# Bat Specialist Walkthrough Report for the Umsinde Emoyeni Wind Energy Facility

IWS Ref No: 3027\_rev2

Date: 25 April 2022 – revised 6 May and 26 October 2022

Figure 3 Updated bat sensitivity map in relation to the previous proposed layout of infrastructure for the proposed Umsinde WEF

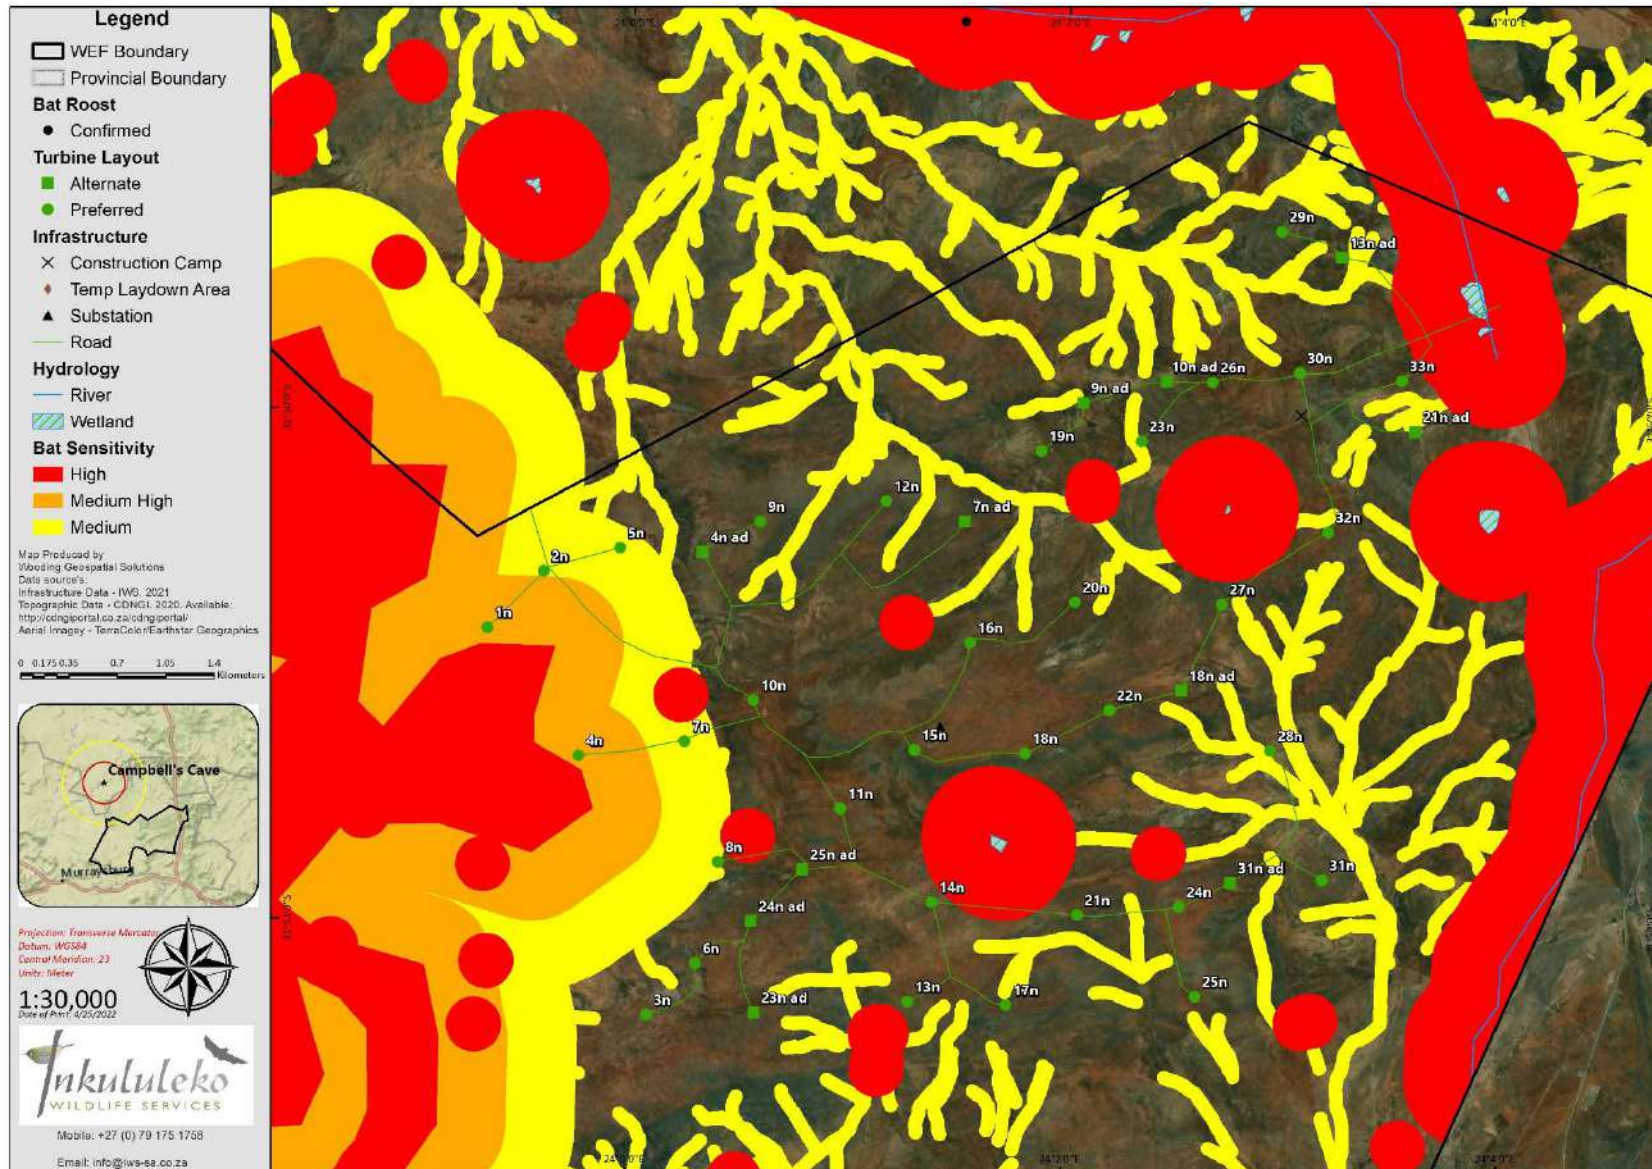
Six features were identified, which require buffering that was not previously included in the Umsinde WEF bat sensitivity layer. Five water supply points (each represented by a farm reservoir, livestock drinking trough, and/or wind pump) were found at Waypoints W1, W2, W27, W28 and W29, and a small but distinct rocky outcrop was encountered at W30. Each of these six features has been buffered with a 200 m High sensitive buffer. The additional buffering does NOT overlap with any proposed infrastructure for the Umsinde WEF.

At five proposed turbine positions (i.e. preferred positions 2 n, 5 n, 7 n, 8 n, and 23 n), the turbine bases coincide with Medium bat sensitive areas, and the blades coincide with Low-Medium, Medium, Medium-High and/or High sensitive areas. Preferred turbine position 5 n is situated ~100 m from the rim of a gorge with a stream and, therefore, its re-positioning by 90 m to the south should be considered, if feasible. At preferred turbine position 2 n, 90 m blades will encroach into a Medium-High sensitive area and, therefore, if a turbine is developed here, curtailment will have to be implemented unless it is repositioned >90 m away from Medium-High sensitive areas. At preferred turbine position 8 n, 90 m blades will encroach into a High sensitive area and, therefore, this position must be dropped or re-positioned.

Two proposed turbine positions are situated in Medium-High sensitive areas. The base and 90 m blades of a turbine at preferred position 1 n will coincide with a Medium-High sensitive area and, therefore, turbine curtailment will have to be implemented unless it is repositioned >90 m away from Medium-High sensitive areas. At preferred turbine position 4 n, 90 m blades will encroach into a High sensitive area and, therefore, this position must be dropped or re-positioned.

Based on the reported infrastructure-associated bat sensitivities, development of turbines is NOT advised at preferred turbine positions 4 n and 8 n unless these turbines are repositioned to be >90m away from the High sensitivity areas. If preferred turbine positions 1 n and 2 n are not re-positioned, curtailment of turbines at these positions will need to be implemented. Re-positioning should be considered for preferred turbine position 5 n, and alternative turbine position 23 n ad, if feasible.
